2007 Annual Report Shepley's Hill Landfill

Devens, Massachusetts

Draft Responses to MassDEP Comments on 2007 Annual Report Shepley's Hill Landfill and Treatment Plant Long Term Monitoring and O&M Services Former Fort Devens, Massachusetts May 2008

H:\ShepleyLandfill\Task11\WXD\Figure4-2.mxd H:\ShepleyLandfill\Task11\Export\Figure4-2.pdf April 16, 2008 DWN: DJK CHKD: KMP

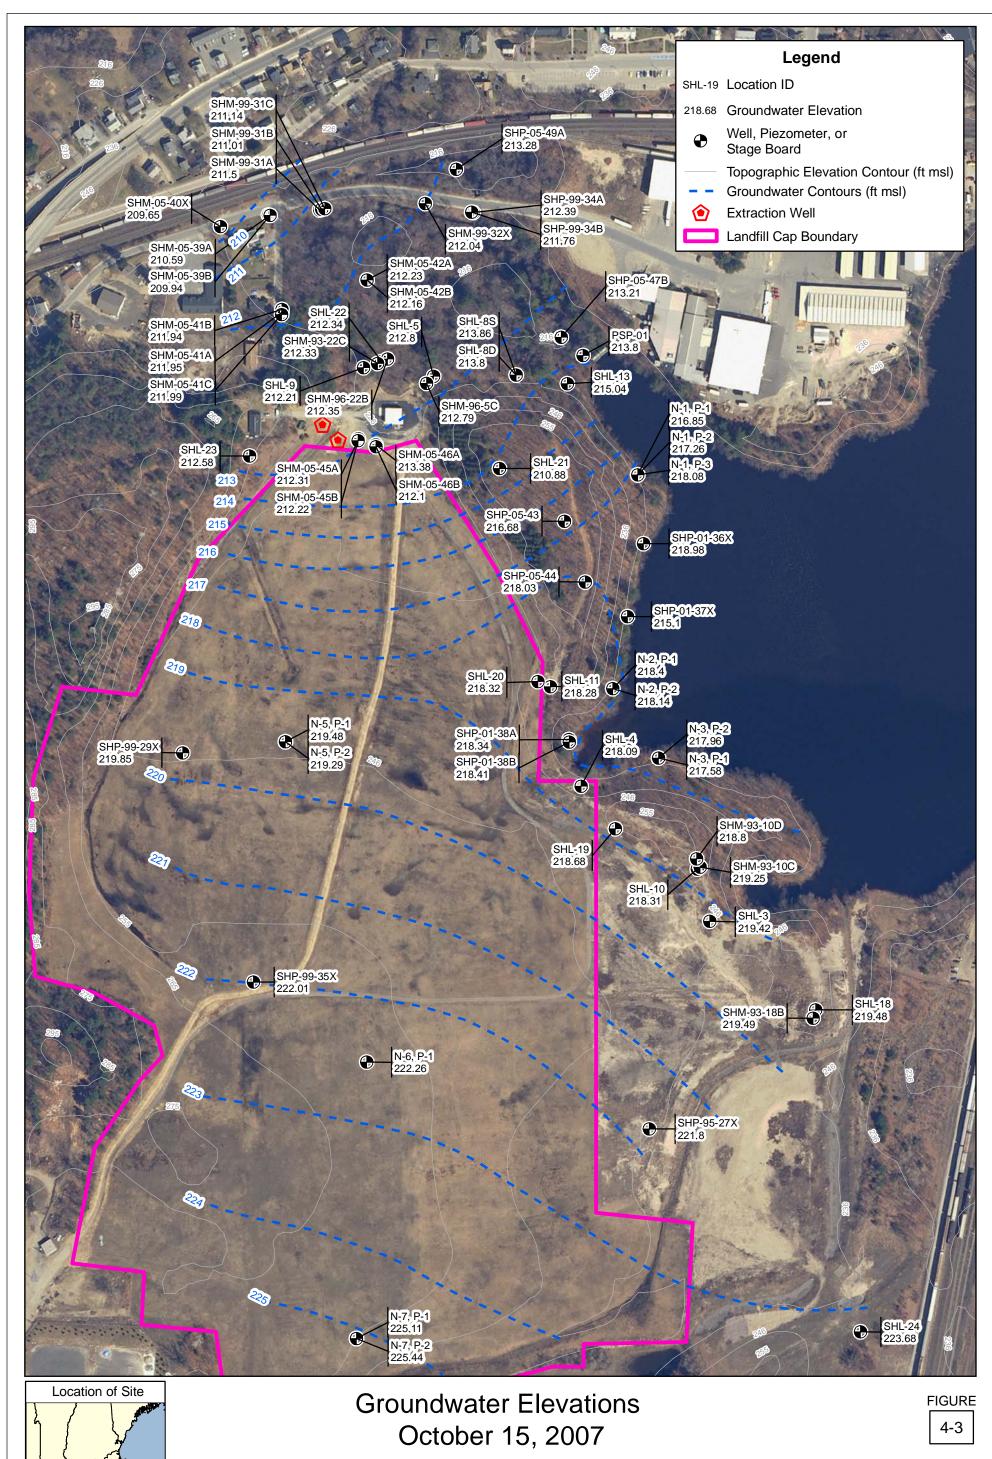
18. Page 4-1, Section 4.1, <u>Groundwater Elevations, Table 4-2, and Figure 4-2</u>. Please note that there is an apparent error in the water level reported for N5-P2 on April 8, 2007 (see also the field sheet in Appendix D). Continuous logging in the N5 piezometer pair suggests that the head in the deeper (bedrock) screen (P1) is typically higher than the shallow (overburden) screen (P2) under spring, high-water conditions, and that head differences are typically of the order of a few tenths of a foot, in contrast to the 3.62 ft difference (of opposite sign) reported here. A transducer in N5-P2 indicated an elevation of about 220.1 ft msl on April 8. The difference between P1 and P2 was about 0.5 ft (higher in the BR) about two weeks following

the gauging reported here (and following an exceptionally large rainfall event from April 15 to 17). Please indicate in the text that the reported water level for N5-P2 in April is suspect. The contouring shown in Figure 4-2 appears to use the deep (P1) result, which is likely closer to the true level of the water table, so the figure does not require correction.

5. In Figure 4-2, it seems water level at N-5 P-1 was used for the groundwater counter, instead of N-5 P-2. In addition, please explain the water level difference of more than three feet between these two wells.

Horizontal Hydraulic Gradient Vectors: October 15, 2007, February 25, 2008, and March 4, 2008

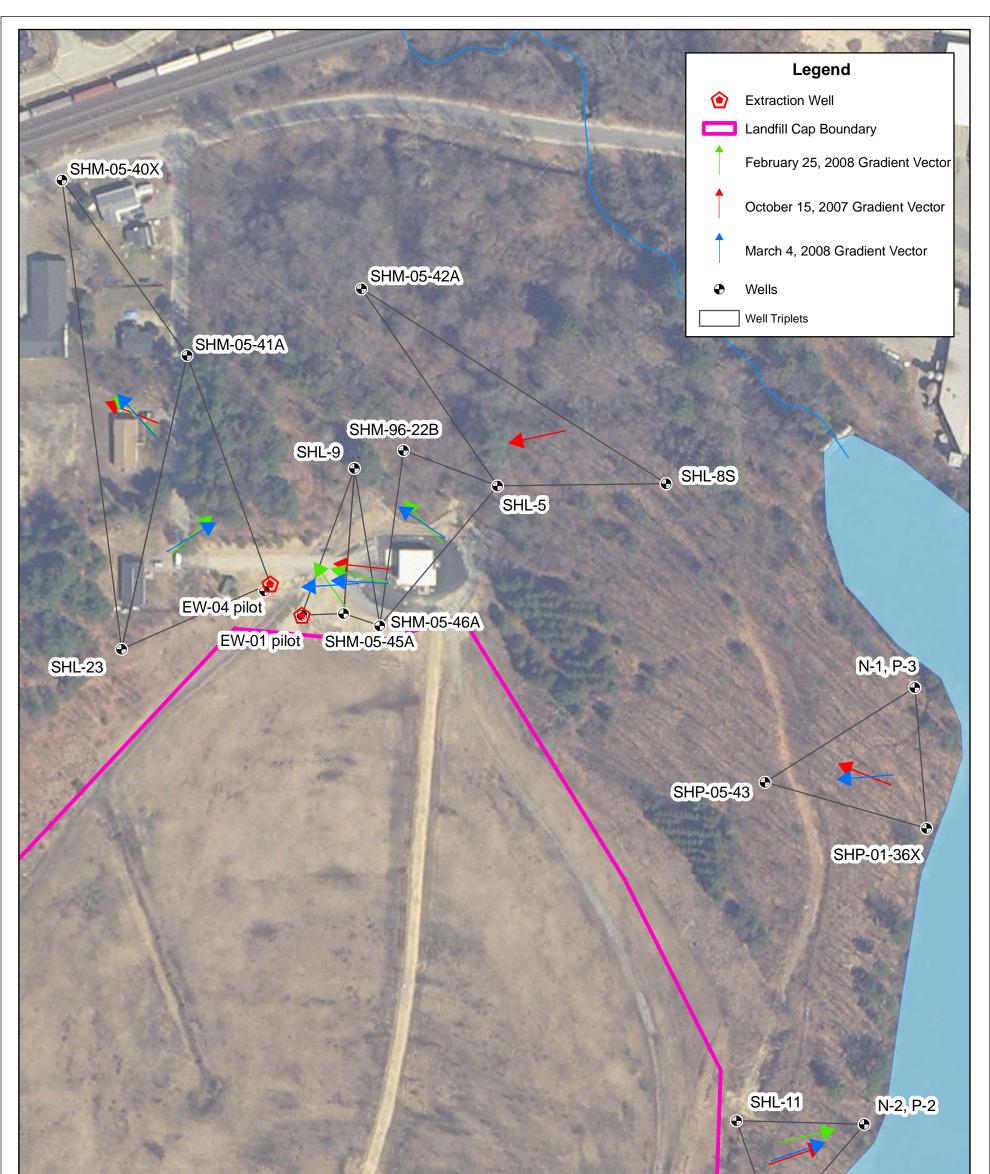
14. To evaluate the usefulness of the vector analysis (Fig 5-1), provide supporting explanation.

Figure 5-3. Continuous Water Level Changes Recorded during Drawdown Assessment 2007 Annual Report

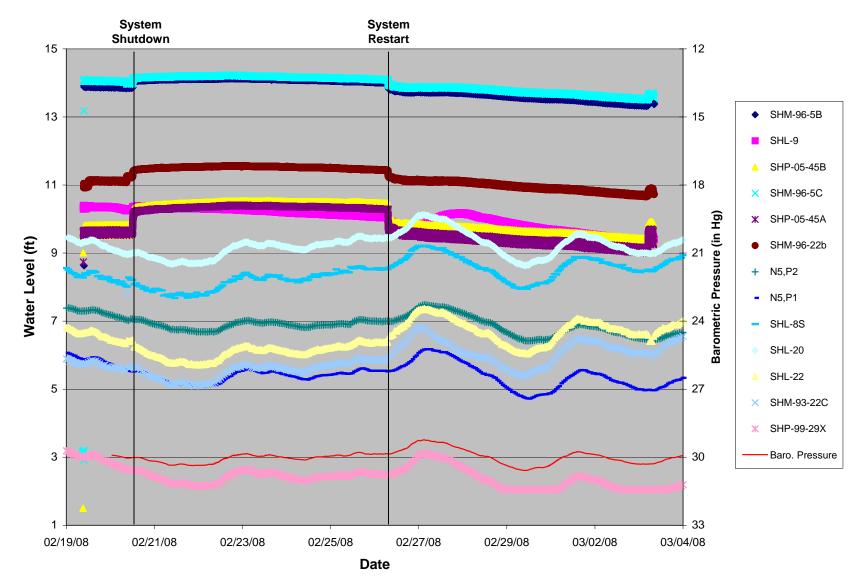
22. Page 5-5, Section 5.2.3, <u>Drawdown Assessment, and Figure 5-3</u>. It is notable that some of the transducer records shown in Figure 5-3 (e.g., the six shown at the top of the plot, with water levels (presumably immersion depths) from 9 to 15 ft) are very smooth, while others

Figure 5-4. Hourly Drawdown Values in Selected Nearfield Wells after System Restart

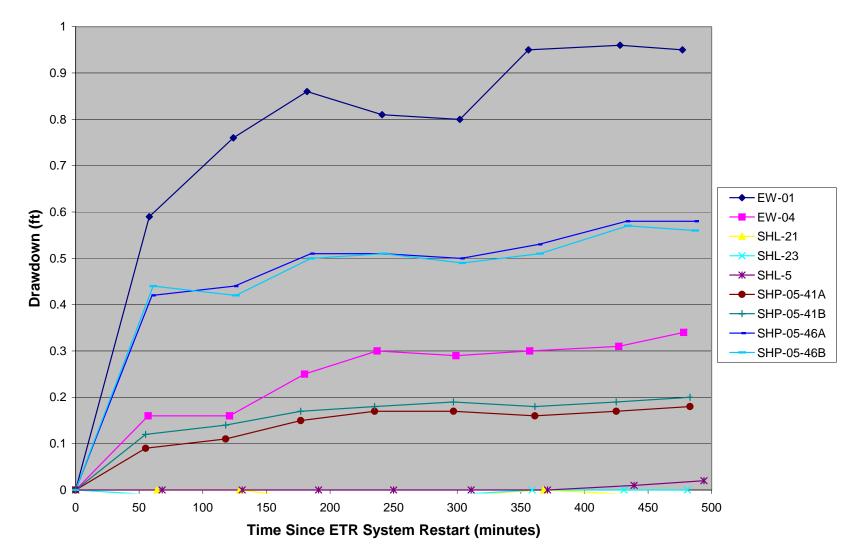
9. In Figure 5-4, please explain why the hourly drawdown values recorded at EW-04 pilot and EW-01 pilot are significantly different.

H:\ShepleyLandfill\Task11\MXD\Figure5-5.mxd H:\ShepleyLandfill\Task11\Export\Figure5-5.pdf April 10, 2008 DWN: DJK CHKD: KMP

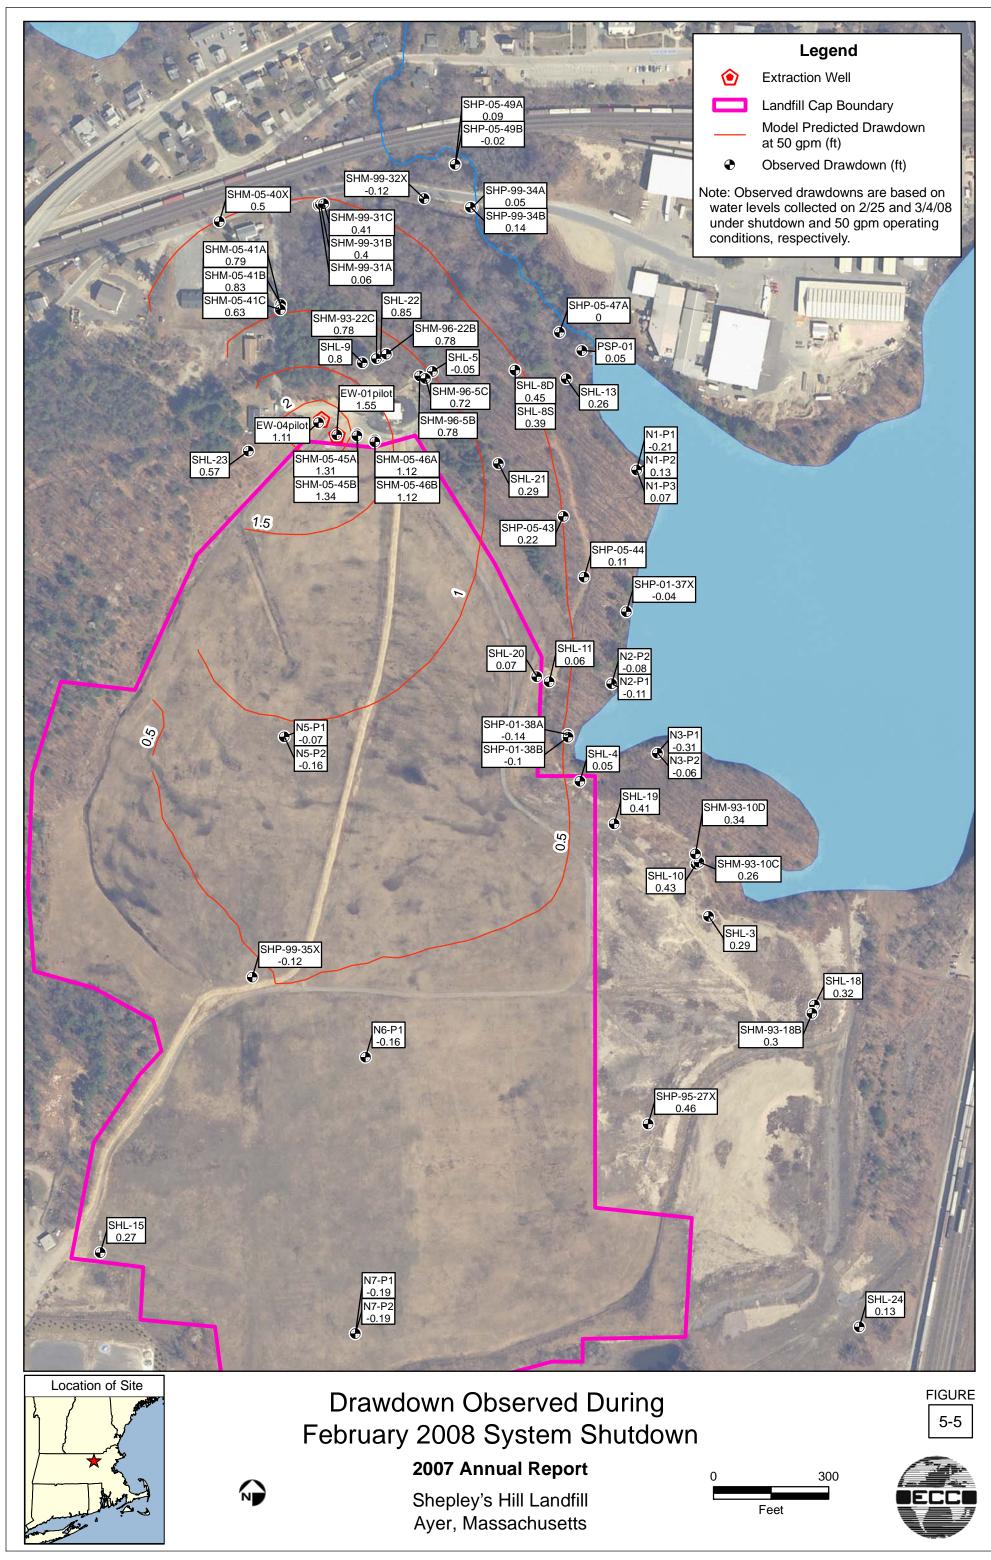
23. Page 5-6, Section 5.2.3, <u>Drawdown Assessment</u>. It might be noted that another reason that the modeled and observed water levels may differ in the nearfield of the pumping wells is that the finite difference grid cannot resolve heads local to the pumping wells with sufficient spatial accuracy. Nonetheless, the agreement over larger length scales between modeled and observed drawdowns is satisfactory (see, e.g., Figure 5-5)

Figure 5-6. Correlation Between Observed (2/20/08) and Predicted Groundwater Elevations

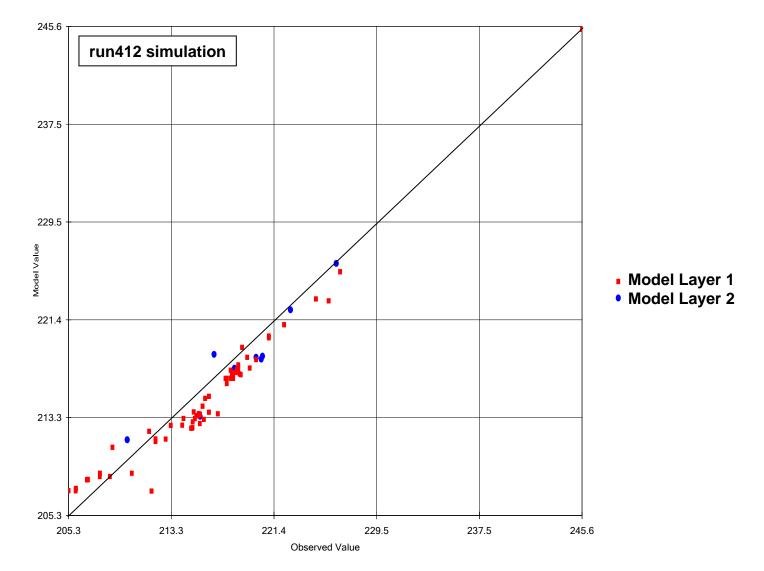
24. Page 5-8, Section 5.2.4, <u>Comparisons to Numerical Model Results</u>. It is agreed that the comparison of computed to observed water levels (Figure 5-6) is satisfactory, and that further calibration of the model should await the refined model currently being developed. It is noted that predicted water levels are generally lower than measured in the upgradient domain (where elevations are higher), and the modeled water levels are generally higher than observed in the downgradient area (where elevations are lower). On the scale of the entire model domain, then, the overall calculated gradient is somewhat lower than is the observed gradient. Assuming that the overall flux of water through the overburden is approximately correct (i.e., that the recharge is represented accurately), this might suggest that the modeled conductivity is a bit high. This should be considered in future model refinements.
